**SUBJECT: Responses to EPA's and Other Agencies' Comments on the
Isolation Barrier Alternatives Analysis
West Lake Landfill Superfund Site, Bridgeton, Missouri**

Responses to Agency Comments Isolation Barrier Alternatives Analysis, West Lake Superfund Site, Bridgeton, Missouri

Attachment G:
Revised Drawing Sheet No. 16

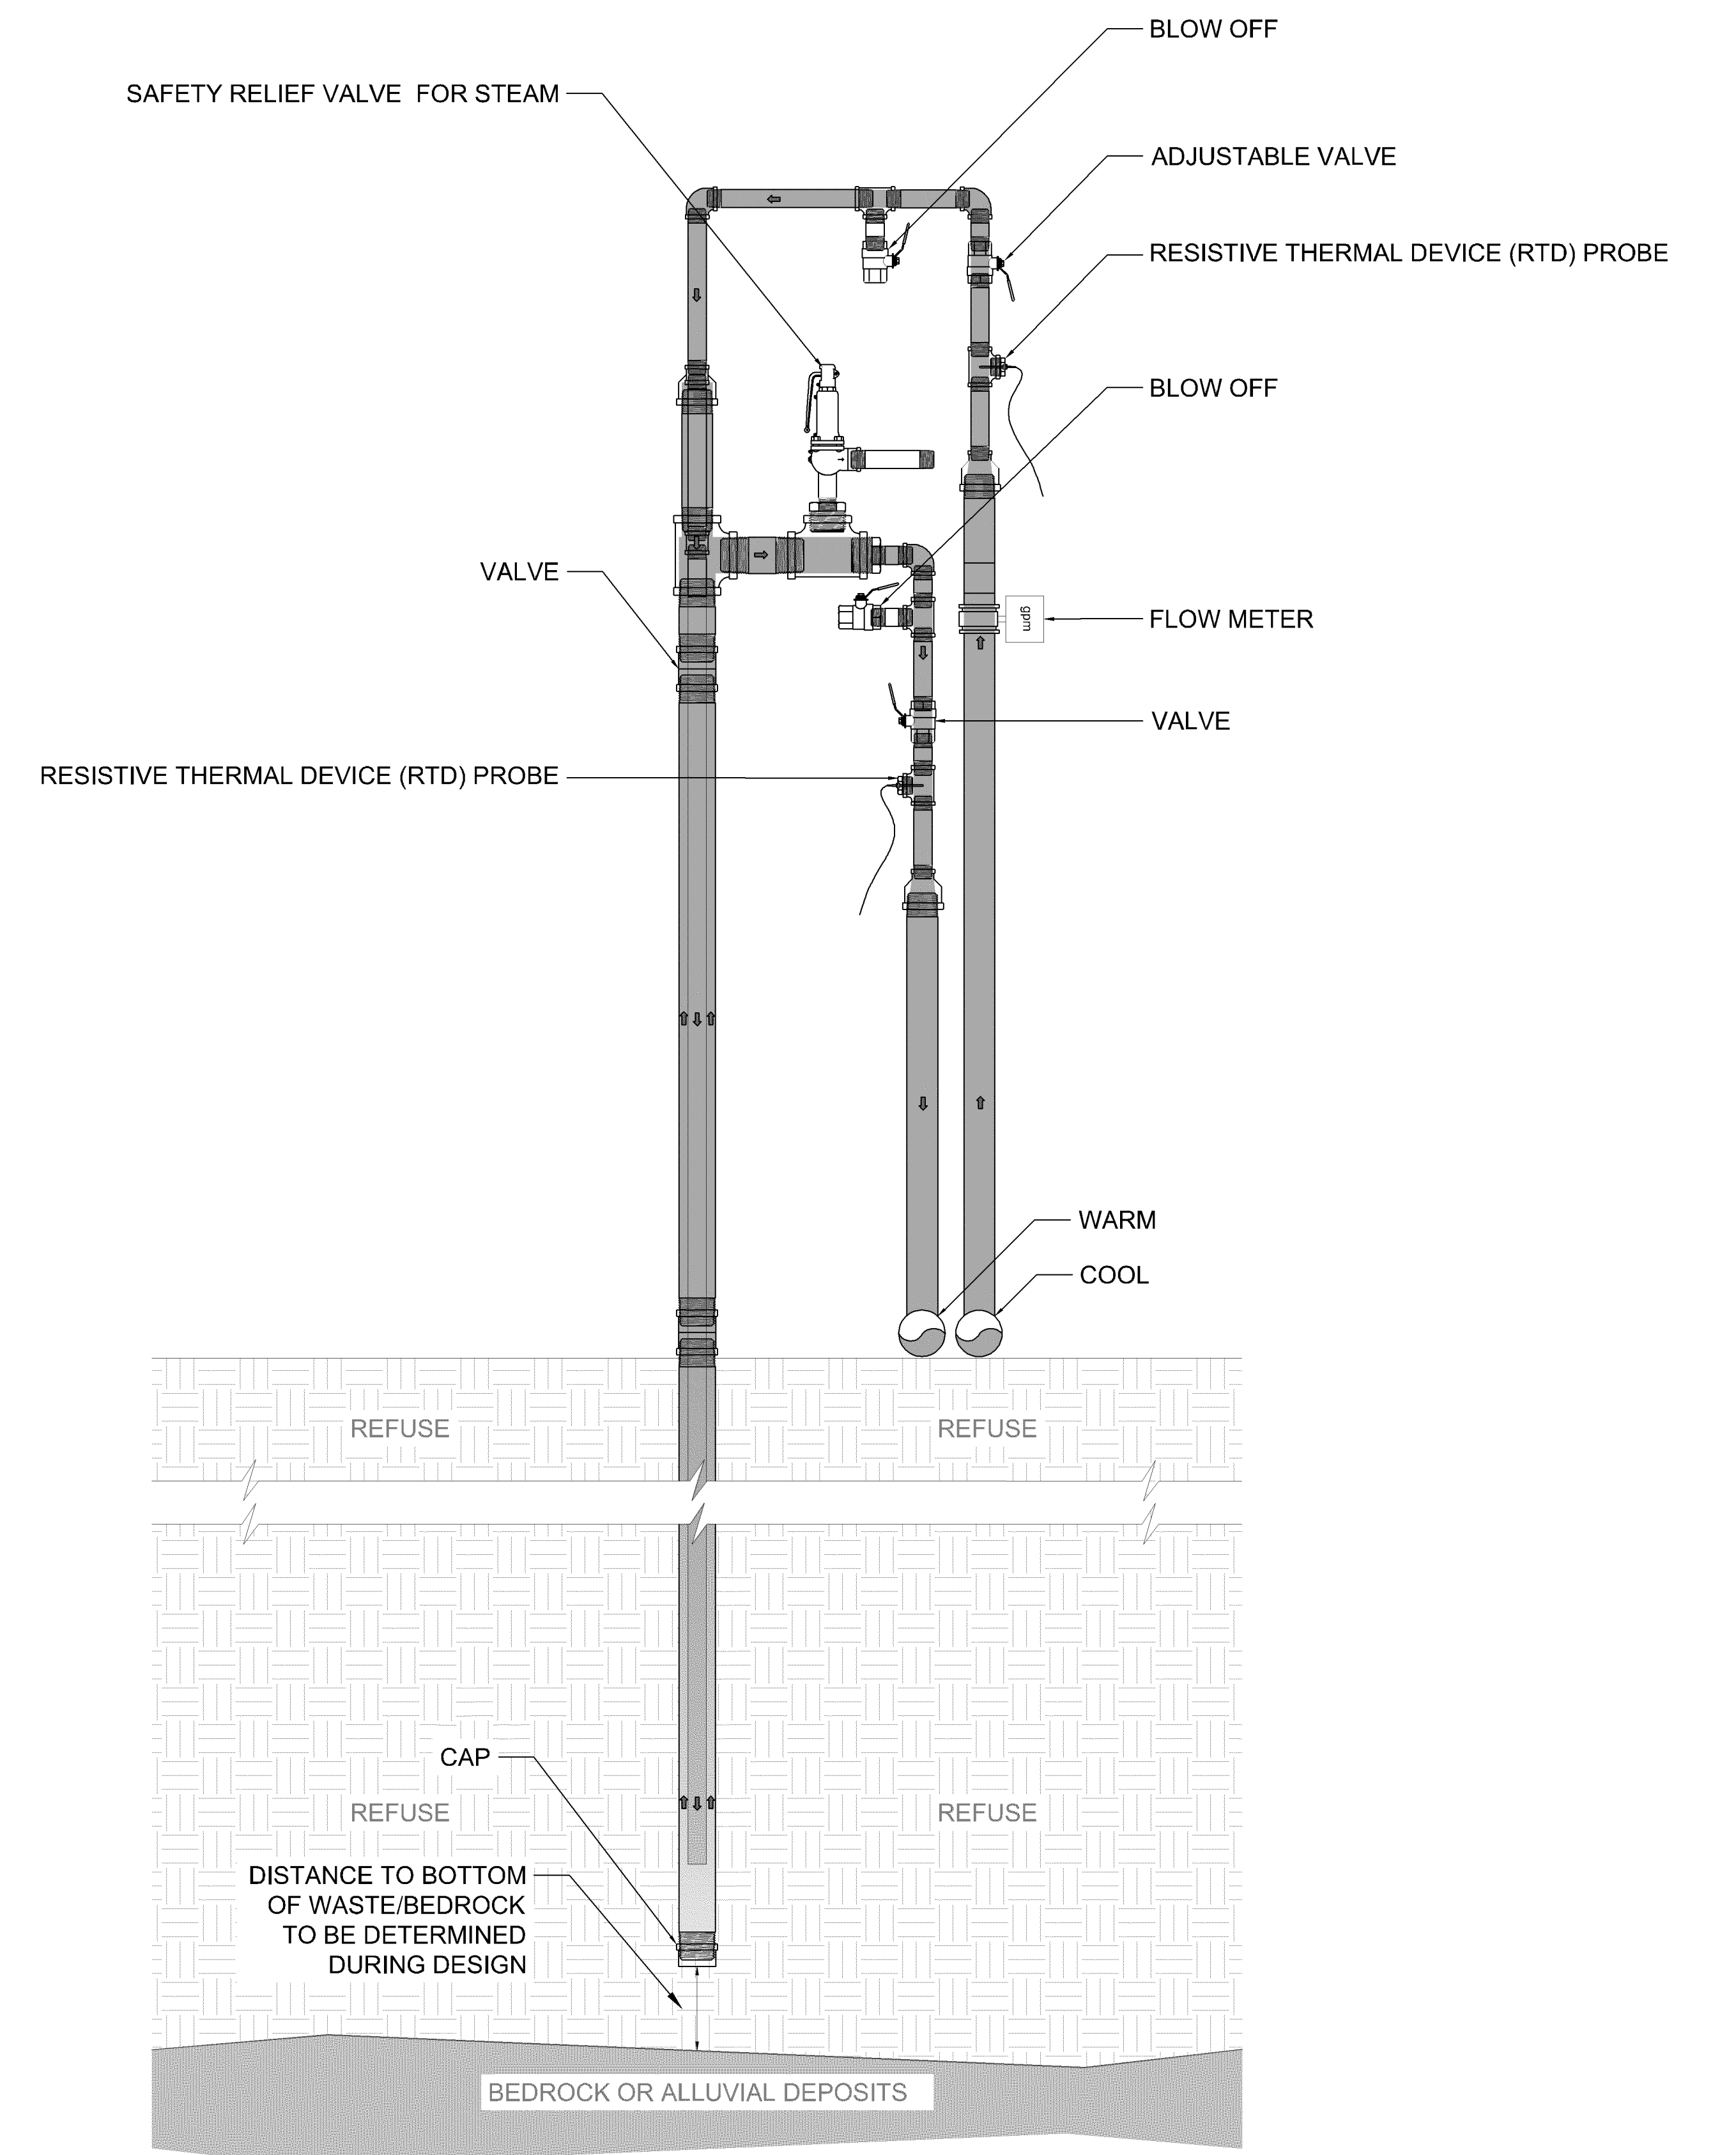
61) Section 7. It is stated that for Option 4, the heat extraction points would be installed such that depths of the extraction points would be relatively shallow. Does this shallow installation still include installation down to the bedrock as indicated in drawing sheet 16'?

76) Drawing 16. The Option 1 and 3 Typical Inert Barrier shows the barrier centerline located in the center of the flat work area. To accommodate the heavy excavation machinery and tooling, the Inert Barrier must be located approximately 45 to 50 feet away from either edge. USACE studies of slope stability show that better global stability factors of safety are obtained when the heavy excavation machinery and tooling is located on the side of the trench opposite the taller excavated slope.
